SERVICE BULLETIN SB99.8

Machines/Models: LX Machines with
outriggers only.

PURPOSE: To enhance drive mode.

OPERATION REQUIRED: Install Ball Switch Adapter on outrigger cylinder.

Figure 1

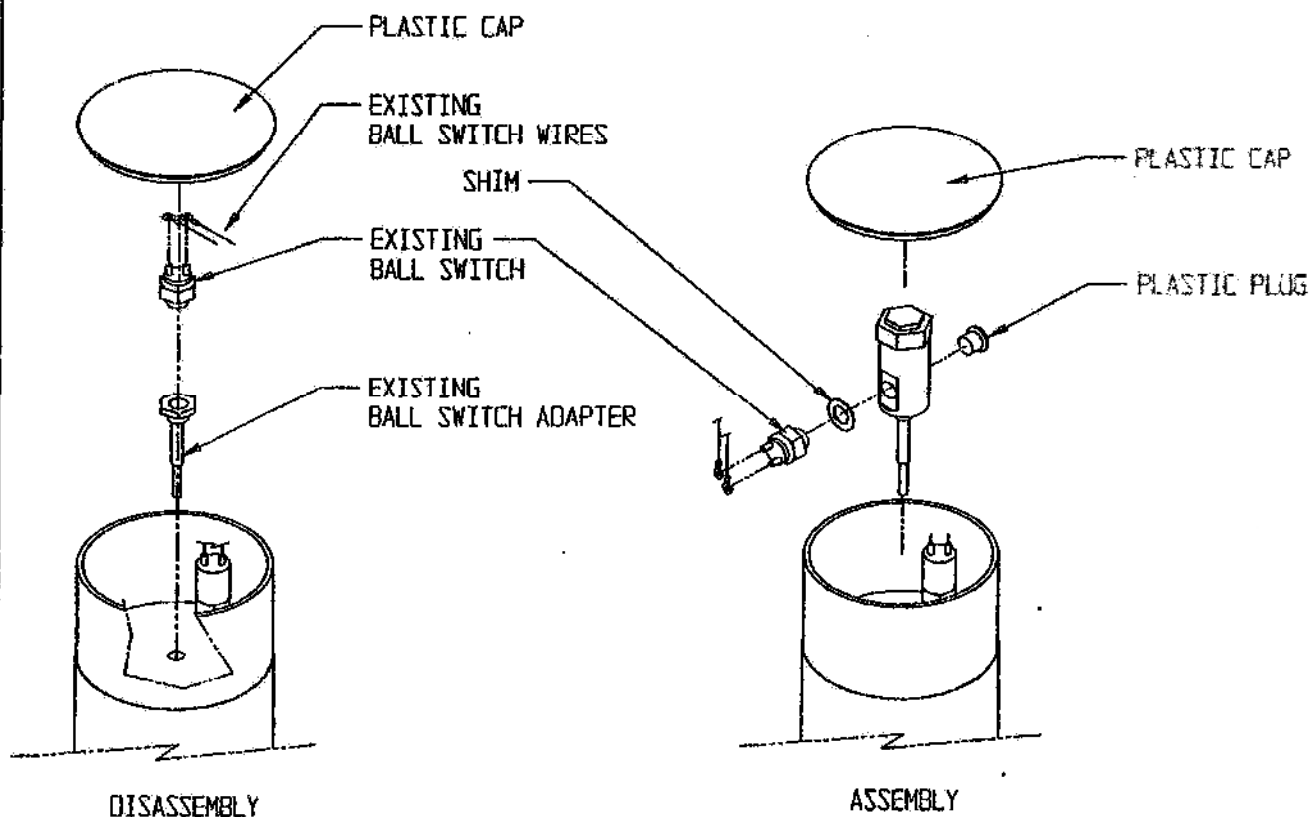
PROCEDURE: Read all instructions thoroughly and refer to Figure 1 before starting.

1. Outriggers must be retracted.
1. Disconnect battery negative.
2. Remove plastic cap from top of outrigger cylinder.
3. Disconnect wires from existing Ball Switch.

4. Remove existing Ball Switch.
5. Remove Ball Switch Adapter.
6. Install new Ball Switch Adapter. (If outrigger is retracted, a downward force will be required to compress spring and allow the threads to engage.)

7. Push plastic dust plug into one of the two holes in the side of the Ball Switch Adapter. (Plug the hole closer to the pressure switch. It may be necessary to trim the outside lip of plug for proper fit.)

8. Install Ball Switch removed in step 4 and reconnect wires. Use shim provided with Ball Switch Adapter
9. Reinstall plastic cap in top of outrigger cylinder.

10. Repeat steps 2 through 9 on the other three outrigger cylinders.
11. Reconnect battery negative.
12. Test all outriggers for proper operation.
13. Operate all four outriggers independently. When each outrigger is extended, the drive light on control box should shut off, indicating that outrigger is down.
